# Work Order ID 95444

Item Name: Crosstube Fwd

DRAWING NO. D206-667-141	TITLE CROSSTUBE ASS'Y (206B HIGH FWD)	REV. C	<b>DART AEROSPACE LTD ENGINEERING ORDER</b>		D.E.O. NO. D206-667-141-C-1	SHEET NO. SHEET 1 OF 1	SCALE NTS
DRAWN <i>q</i>	CHECKED <i>ASS</i>	MFG. APPR. <i>MD</i>	APPROVED <i>MD</i>		DE APPR. <i>MD</i>		
DATE 11.07.15	DATE 11.07.20	DATE 11.07.21	DATE 11/07/21		DATE 11.07.21

DRAWING NO. D206-667-141	TITLE CROSSTUBE ASS'Y (206B HIGH FWD)	REV. C	DART AEROSPACE LTD ENGINEERING ORDER		D.E.O. NO. D206-667-141-C-2	SHEET NO. SHEET 1 OF 1	SCALE NTS
DRAWN AJS	CHECKED	MFG. APPR.	APPROVED		DE APPR.		
DATE 12.08.02	DATE 12.08.02	DATE 12.08.02	DATE 12.08.02		DATE 12.08.02	DATE 12.08.02

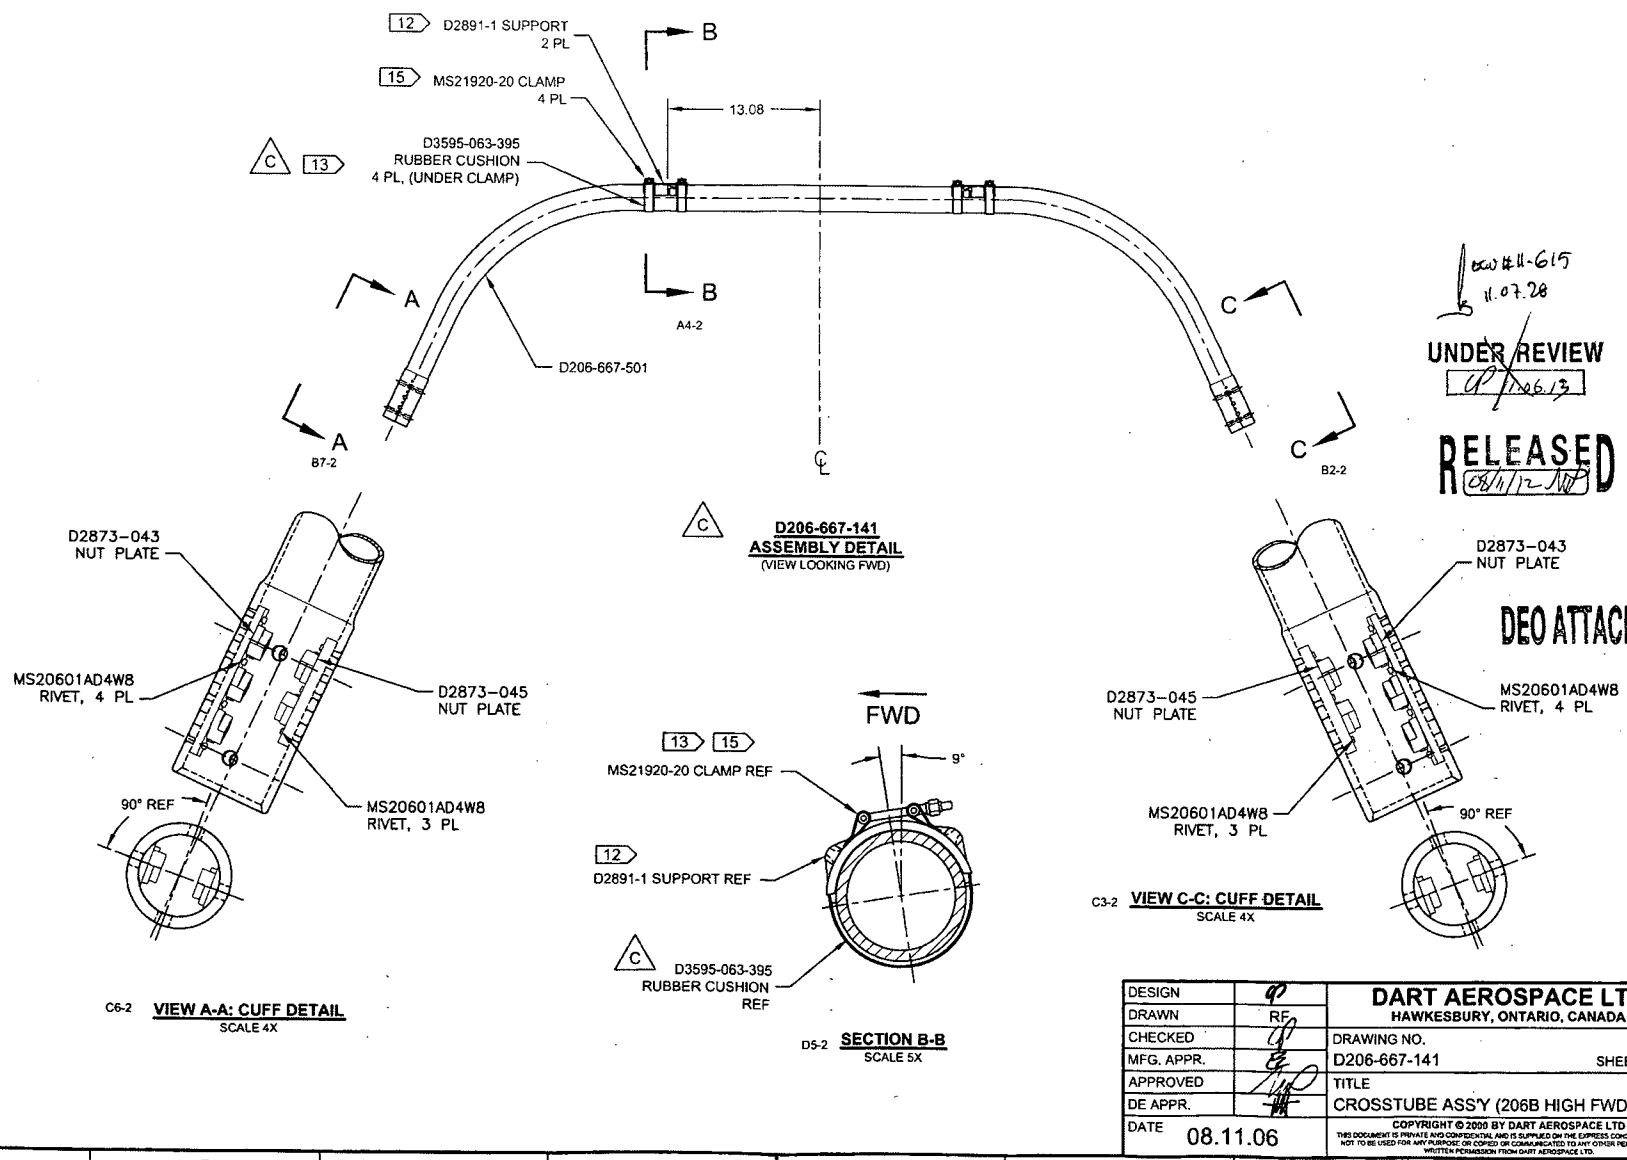
C	REVISE GENERAL NOTES/PART LIST (ZN D7-1); REORGANIZED VIEWS AND REFORMATTED DRAWING TO CURRENT STANDARDS. D3595-063-395 WAS D2856-400-694 (ZN D6-2 & A5-2); REMOVED REF. & ADD TOLERANCES (ZN C4-3, C5-3 & D3-3); RELOCATED FLAG #6 (ZN A8-3) PER NCR 210; MOVED TURNING DETAIL & UPDATED TOLERANCE TO SHEET 4.	RF	08.11.06
B	ADD HOLES AND NUT PLATES FOR COMPATABILITY WITH BHT/AA SKUDTUBES	PH	05.07.26
A	NEW ISSUE	CP	00.11.17
REV.	DESCRIPTION	BY	DATE
DESIGN	RF	DART AEROSPACE LTD HAWKESBURY, ONTARIO, CANADA	
DRAWN	RF	DRAWING NO. D206-667-141	REV. C SHEET 1 OF 4
CHECKED	RF	TITLE CROSSTUBE ASS'Y (206B HIGH FWD)	SCALE NTS
MFG. APPR.	RF	COPYRIGHT © 2000 BY DART AEROSPACE LTD THIS DOCUMENT IS PRIVATE AND CONFIDENTIAL AND IS SUPPLIED ON THE EXPRESS CONDITION THAT IT IS NOT TO BE USED FOR ANY PURPOSE OR COMMUNICATED TO ANY OTHER PERSON WITHOUT WRITTEN PERMISSION FROM DART AEROSPACE LTD.	
APPROVED	RF	DATE 08.11.06

**DETAIL P**  
BONDING STRAP INSTALLATION 2 PL

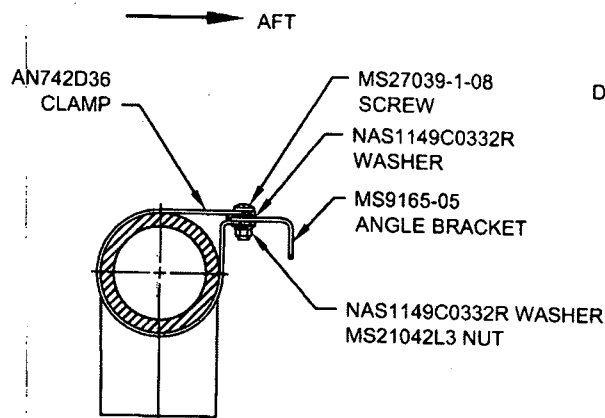
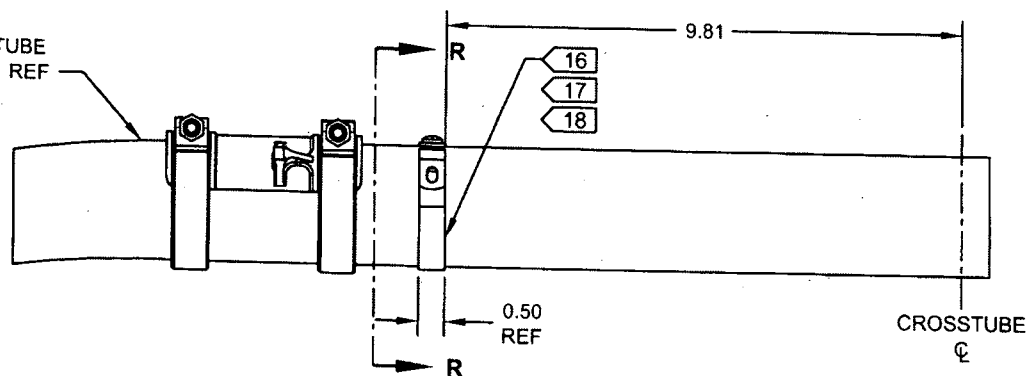
ADD ELECTRICAL GROUNDING STRAP

ADD

ADD

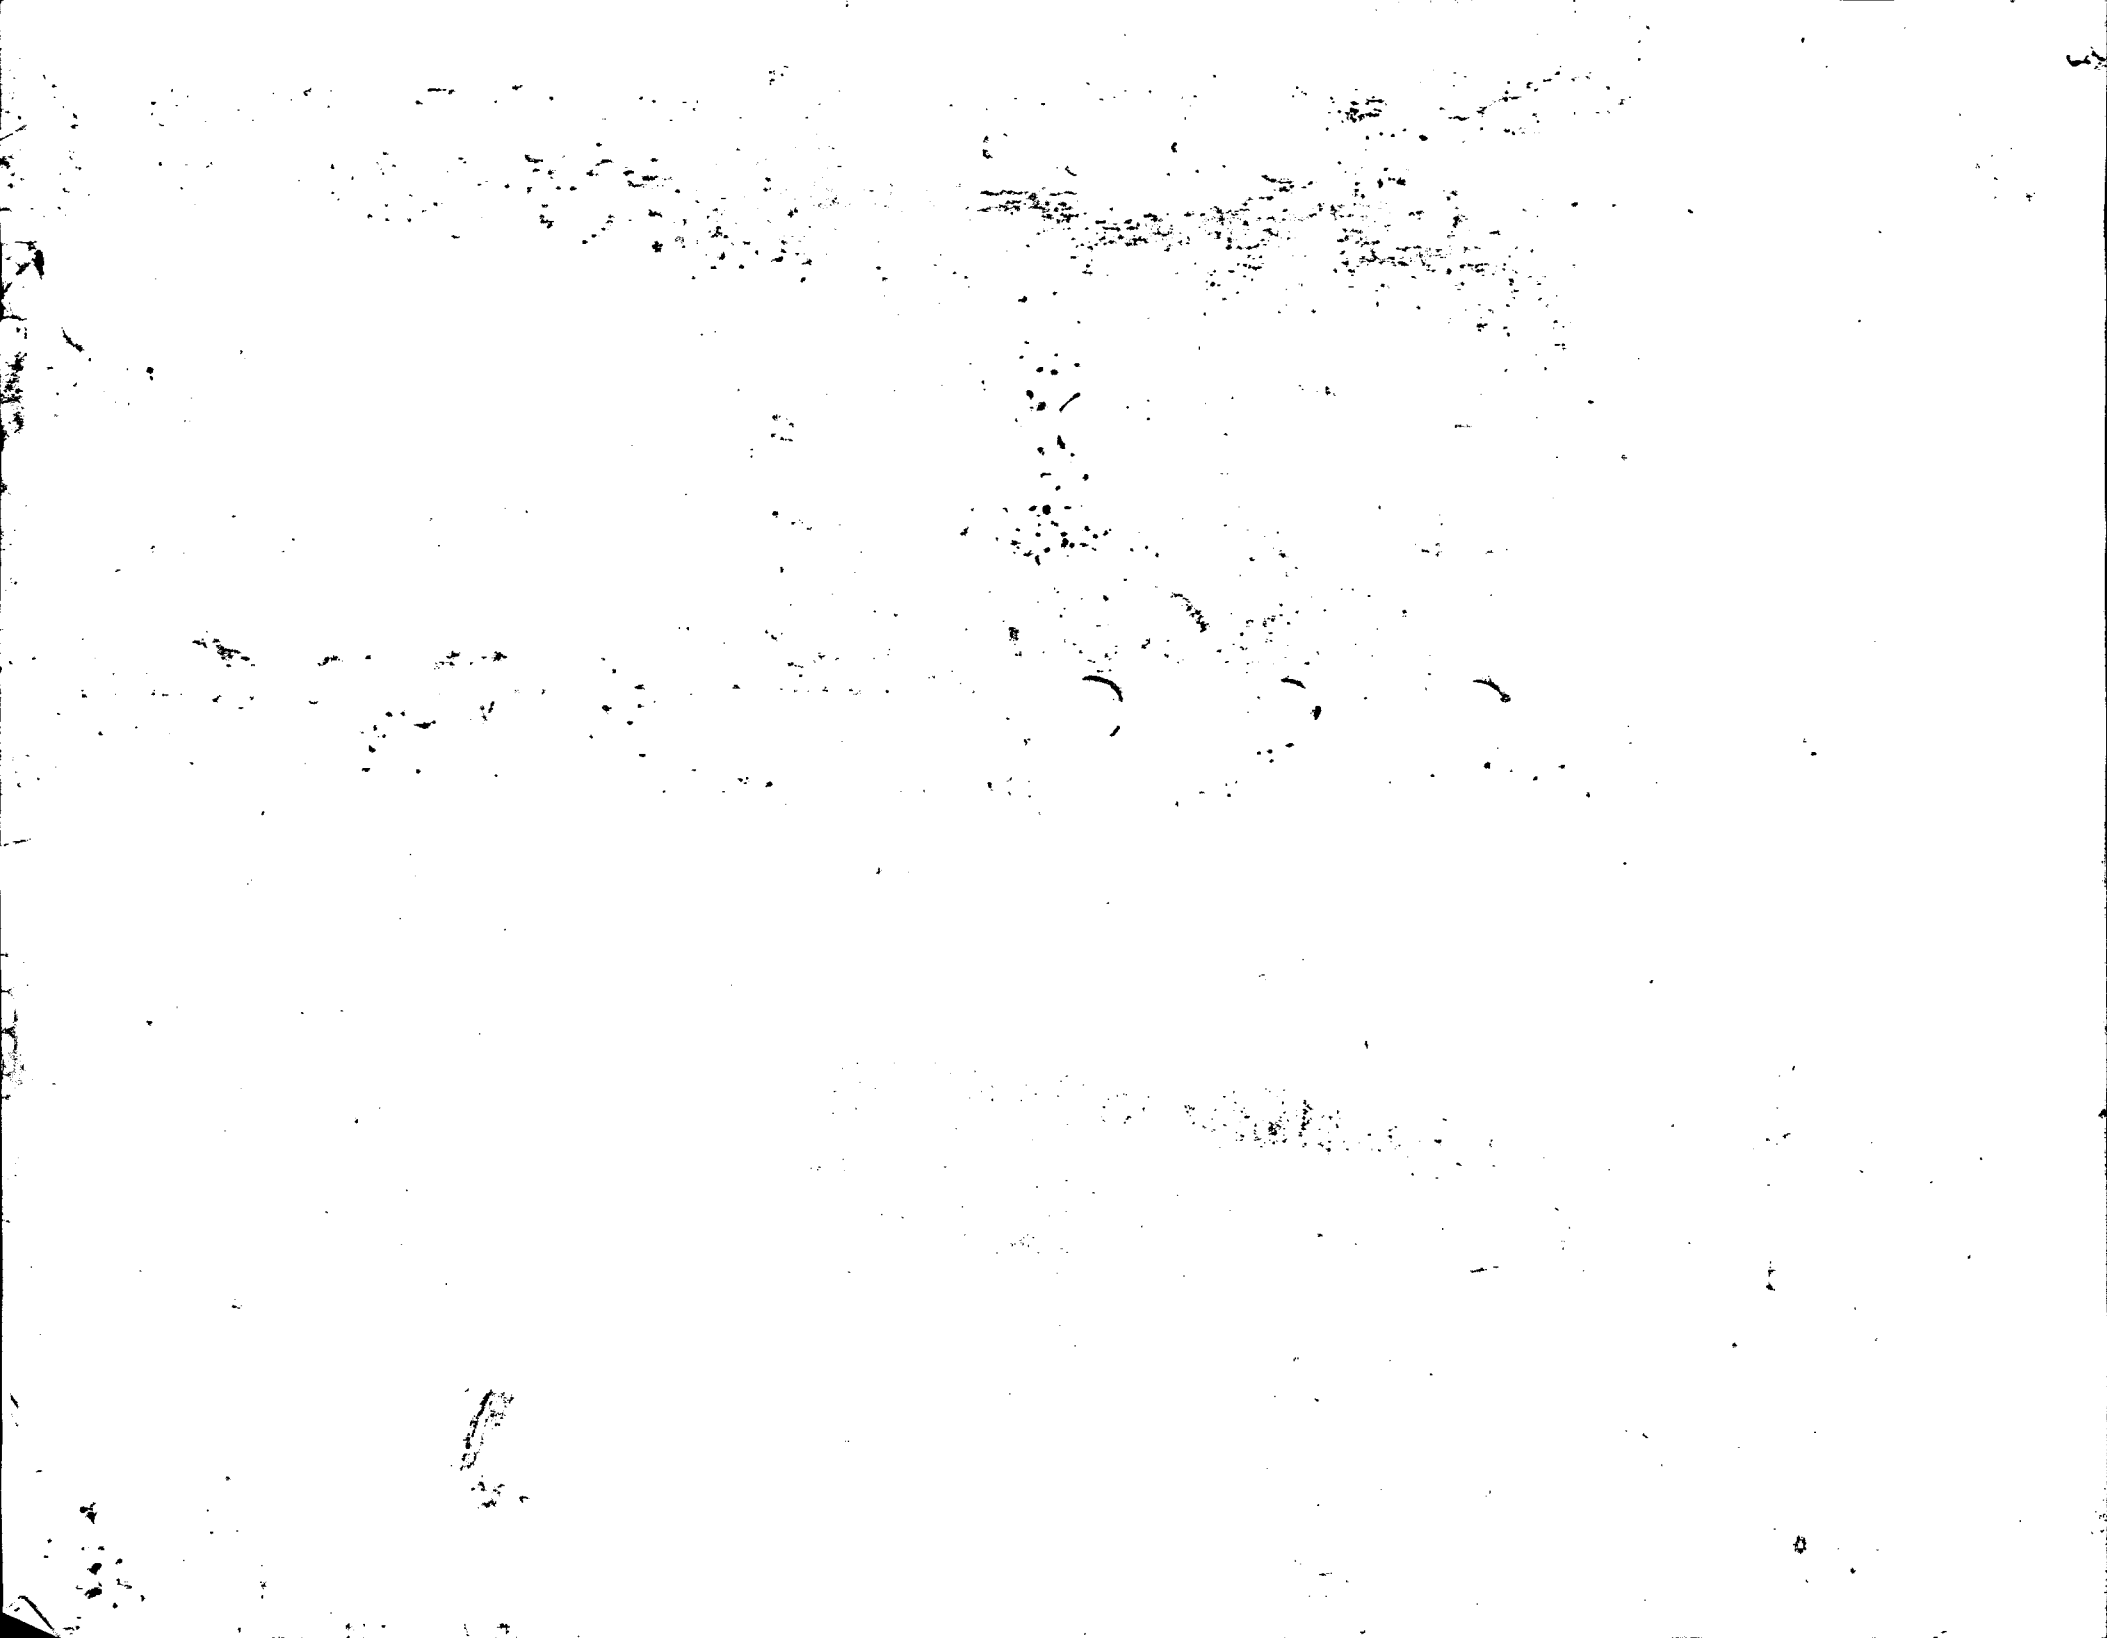
So Tube will break at support before area of 8% crushing - 8% crushing in area at end of bend is acceptable
